PLAT COMMITTEE

Case Number:	2024-PLT-004
Property Address:	5201 E Thompson Road (<i>Approximate Address</i>)
Location:	Franklin Township, Council District #24
Petitioner:	5201 East Thompson, LLC, by Joshua Werner
Zoning:	C-4
Request:	Approval of a Subdivision Plat to be known as Emerson Plaza II, dividing 10.45 acres into one lot and one block, with a waiver of the sidewalk requirement.
Waiver Requested:	Waiver of sidewalks
Current Land Use:	Commercial
Staff Reviewer:	Michael Weigel, Senior Planner

ADDENDUM (March 13, 2024)

2024PLT004 ; 'In Lieu Of' Fee Breakdown if Waiver Approved

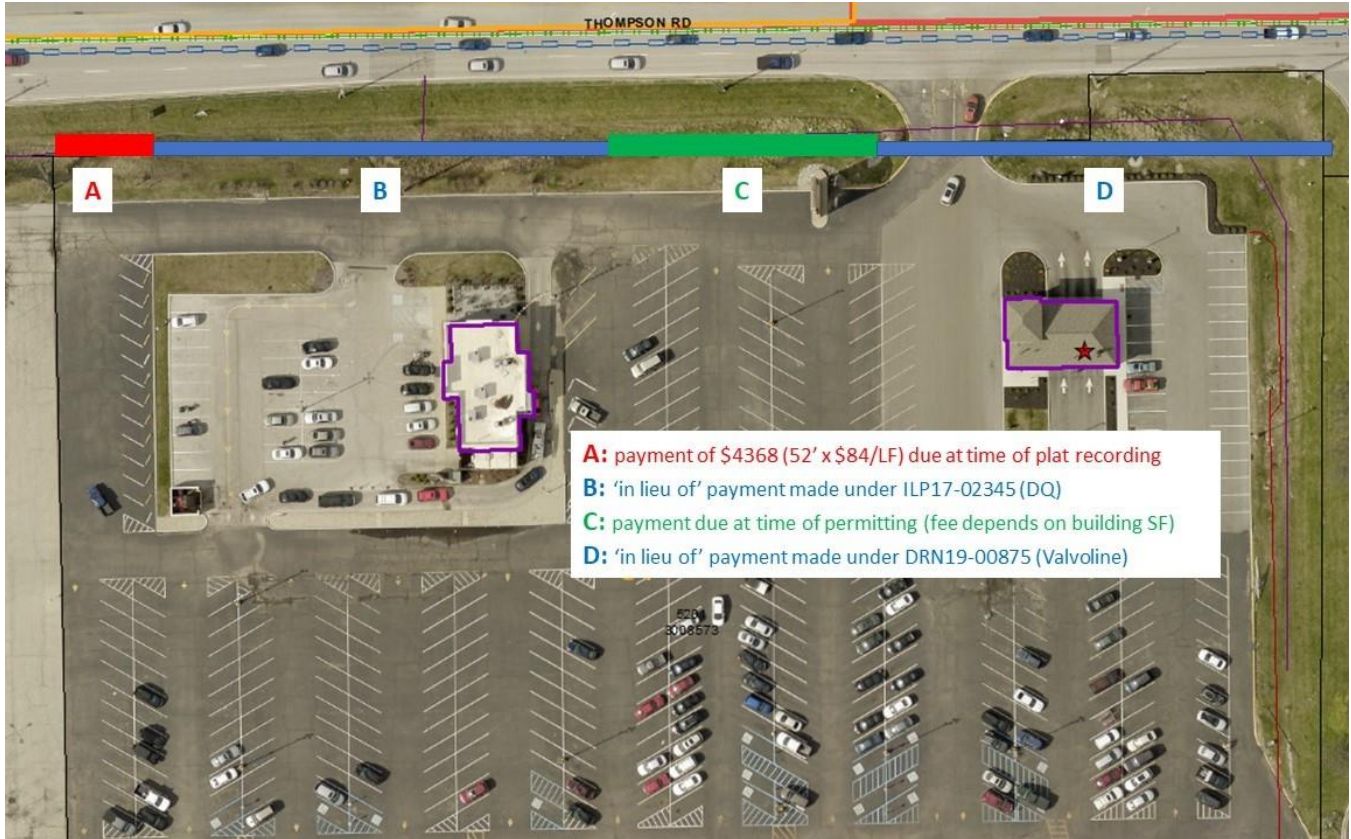
The graphic added to Exhibits provides additional information on (a) 'in lieu of' fees already paid and (b) payments that would be due at the time of platting and of permitting if the sidewalk waiver were to be approved over staff's recommendation.
